**Economic Commission for Europe****Inland Transport Committee****World Forum for Harmonization of Vehicle Regulations****One-hundred-and-fifty-first session**

**1958 Agreement - Consideration of draft  
amendments to existing Regulations****Proposal for Supplement 5 to the 11 series of amendments to  
Regulation No. 13 (Heavy vehicles braking)****Submitted by the Working Party on Brakes and Running Gear \***

The text reproduced below was adopted by the Working Party on Brakes and Running Gear (GRRF) at its sixty-seventh session in order to remove secondary coupling requirements from the Regulation, to update the requirements on trailers, to lower the maximum test speed, to clarify the requirements for electric control transmission and to exempt some special purpose vehicles from electronic stability function requirements. It is based on ECE/TRANS/WP.29/GRRF/2009/12, not amended, informal document GRRF-67-06-Rev.1 as reproduced in Annex III to the report, on ECE/TRANS/WP.29/GRRF/2010/5 as amended by paragraph 8 of the report, ECE/TRANS/WP.29/GRRF/2010/7 as amended by paragraph 9 of the report, on ECE/TRANS/WP.29/GRRF/2010/13 as amended by paragraph 12 of the report, on ECE/TRANS/

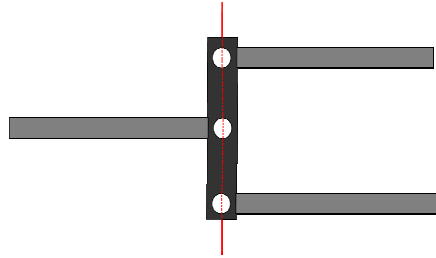
Insert new paragraphs 8. to 8.1.2., to read:

- “8. SIMULATED GRADIENT PARKING BRAKE FORCE DIFFERENTIAL
- 8.1. Calculation method
- 8.1.1. The pivot points in the compensator shall lie in a straight line with the park brake at the rest position.

**All compensator pivots to be in-line**

Alternative arrangements can be used, if they provide equal tension in both rear cables, even when there are differences in travel between the rear cables.

- 8.1.2. Drawing details are to be provided to demonstrate that the compensator articulation is sufficient to ensure equal cable tension is applied to each of the rear cables. The compensator needs to have sufficient distance across the width to facilitate the differential travels left to right. The jaws of the yokes also need to be deep enough relative to their width to make sure that they do not prevent articulation when the compensator is at an angle.

Differential travel at compensator ( $s_{cd}$ ) shall be derived from:

$$s_{cd} \geq 1.2 \cdot (S_{cr} - S_c')$$

$S_c' = S'/i_H$  (travel at compensator - forward operation) and  $S_c = 2 \cdot S_B/i_g$   
 $S_{cr} = S_r/i_H$  (travel at compensator - rearward operation)”

“Figure 5A: MECHANICAL-TRANSMISSION BRAKING SYSTEM  
(See paragraph 2.3. of this annex)

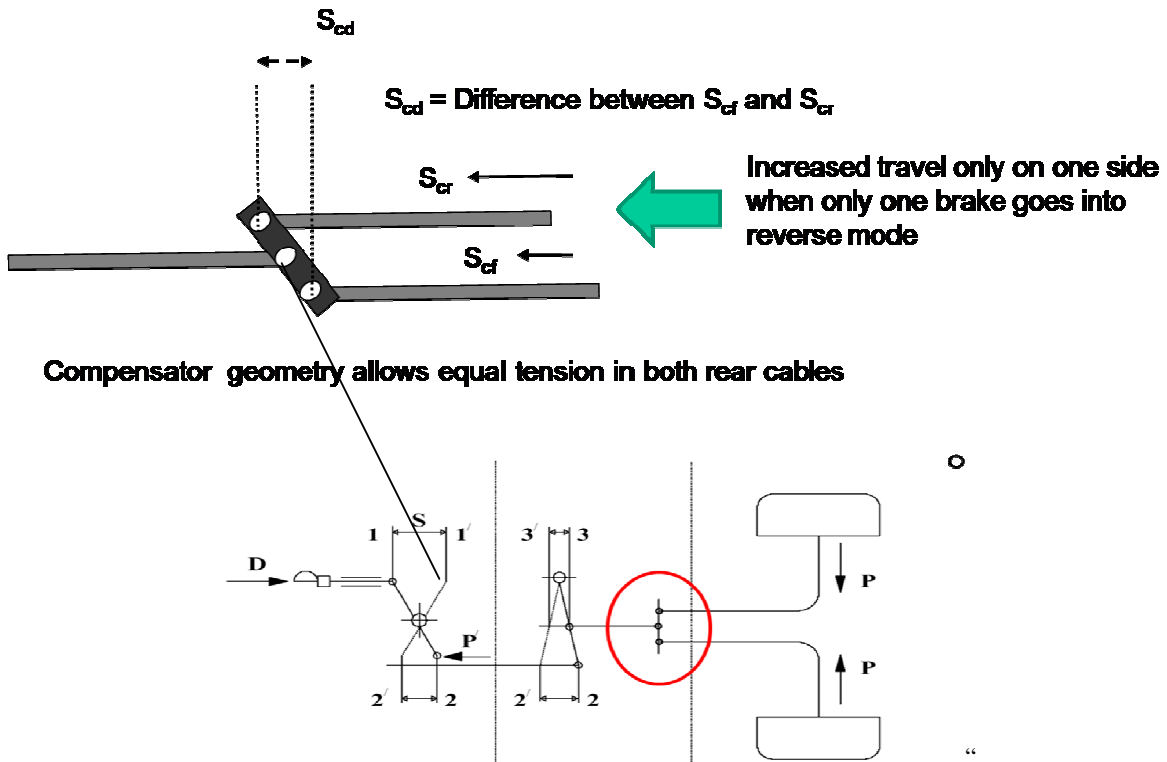
Annex 12, Appendix 1, insert a new figure 5A, to read:
